# ADDENDUM NO. 3

HAONVER STREET GARAGE RESTORATION

DATE OF ISSUANCE: February 22, 2022 WALKER PROJECT #: 16-003129.00  
OWNER: City of Portsmouth, NH  
CONTRACT FOR: Hanover St, Garage Restoration

### 3.3 FLOOR REPAIR - FULL DEPTH AT CONSTRUCTION JOINT

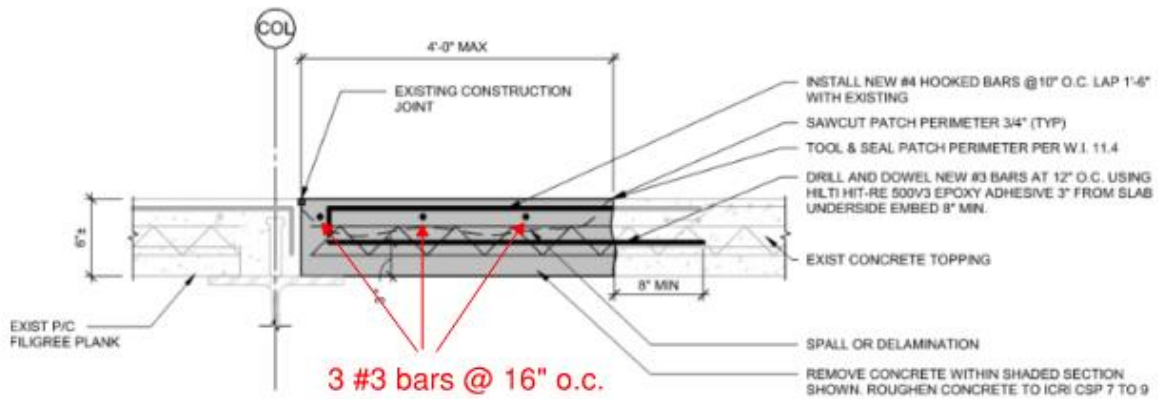
- NOTE:**
1. CONTRACTOR SHALL TEMPORARILY SHORE PLANKS PRIOR TO DEMOLITION. SHORING OF THE STRUCTURE IS THE SOLE RESPONSIBILITY OF THE CONTRACTOR. TEMPORARY SHORING SHALL REMAIN IN PLACE UNTIL CONCRETE REPAIRS HAVE FULLY CURED. CONTRACTOR SHALL SUBMIT STAMPED AND SEALED SHORING DRAWINGS AND CALCULATIONS BY REGISTERED ENGINEER IN THE STATE OF NEW HAMPSHIRE TO E.O.R. FOR RECORD PRIOR TO START OF WORK.
  2. CONTRACTOR SHALL NOTIFY ENGINEER IF CONCRETE REMOVAL LIMITS EXCEED 4'-0" FROM THE CONSTRUCTION JOINT AS SHOWN ON DRAWINGS.
  3. CONTRACTOR SHALL NOTIFY ENGINEER IF ONE REINFORCING BAR HAS LOST MORE THAN 20% CROSS SECTION OR IF TWO ADJACENT BARS HAVE LOST MORE THAN 10% CROSS SECTION EACH.

What is the size of the three longitudinal bars in detail 3.3?

**Response:** The existing bars are #3 reinforcing steel bars indicated in the sketch above. They may remain if they are not corroded by more than 15% of sectional loss per bar. Replacement bars shall be #4.
